Interoffice Memorandum

Subject: Review of model for Lovelace Biomedical Research Institute – South Facility

Permit # 0917-M6

Figure 1. Source layout

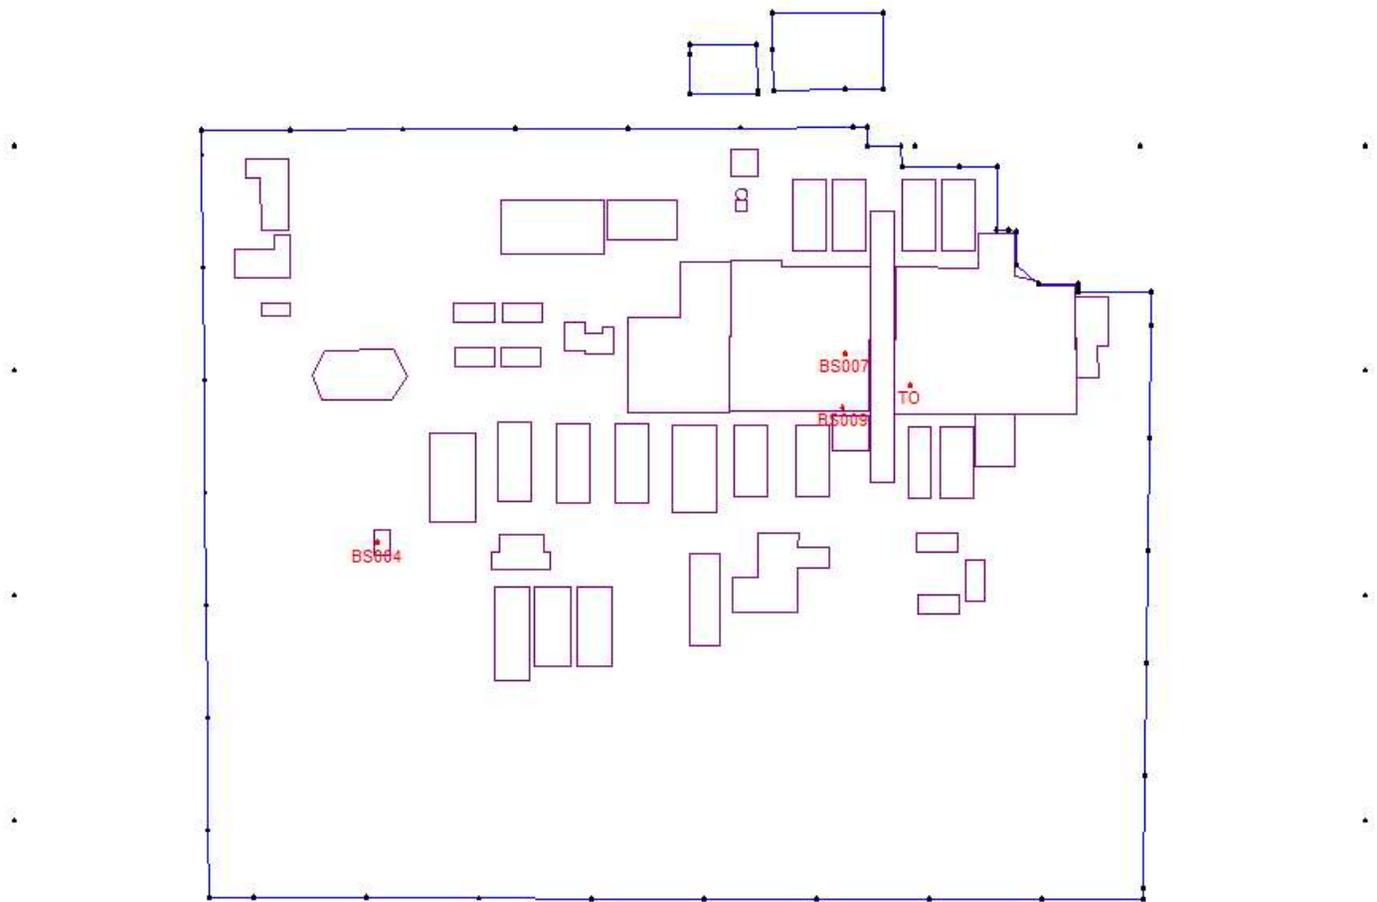
1. Operating hours: 24 hours/day, 7 days/week
2. A fence or some other barrier restricts access to the property, with the exception of the northeast boundary. The edge of the building near the main entrance was used as the fence line.
